# REVISION LIST

## CHAPTER 22: CABIN VENTILATION

The following list of revisions will allow you to update the Legacy construction manual chapter listed above.

Cabin Ventilation  
Fig 22:A:1

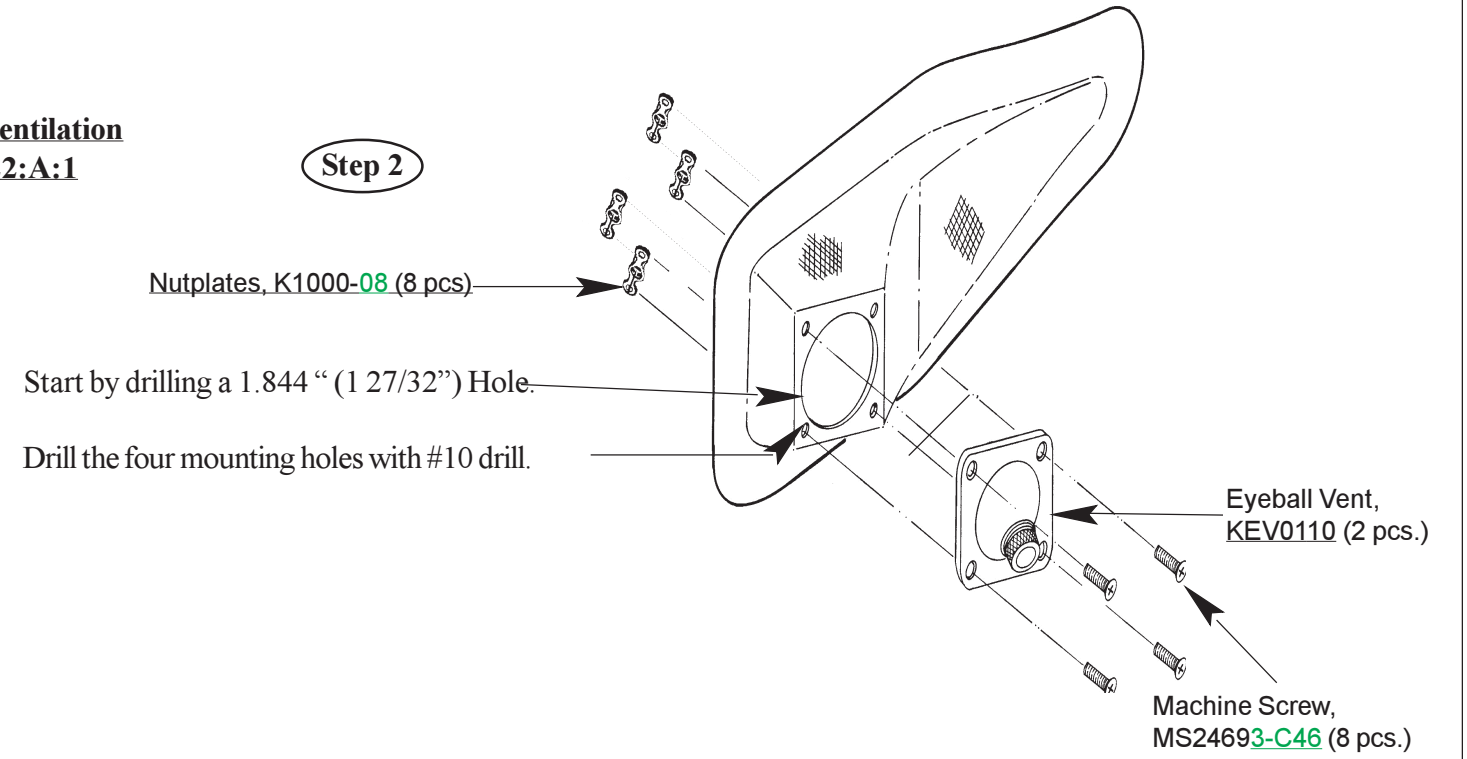
PAGE(S) AFFECTED	REVISION # & DATE	ACTION	DESCRIPTION
22-1 through 22-2	0/02-15-02	None	Current revision is correct
22-3	0/09-18-02	R&R	Corrected Fig. 22:B:1
22-4	0/09-18-02	R&R	Text Correction
22-1	2/06-30-04	R&R	Updated parts list.
22-2	2/06-30-04	R&R	Corrected figure 22:A:1.
22-1	3/12-15-04	R&R	Updated table of contents with page numbers.
22-3	3/12-15-04	R&R	Removed reference to figure 22:B:3 which does not exist.
22-1	4/09-30-06	R&R	Corrected two part nbrs. in parts list.
22-2	4/09-30-06	R&R	Corrected two part nbrs.
22-1, 22-3	6/08-10-07	R&R	Changed part numbers only.
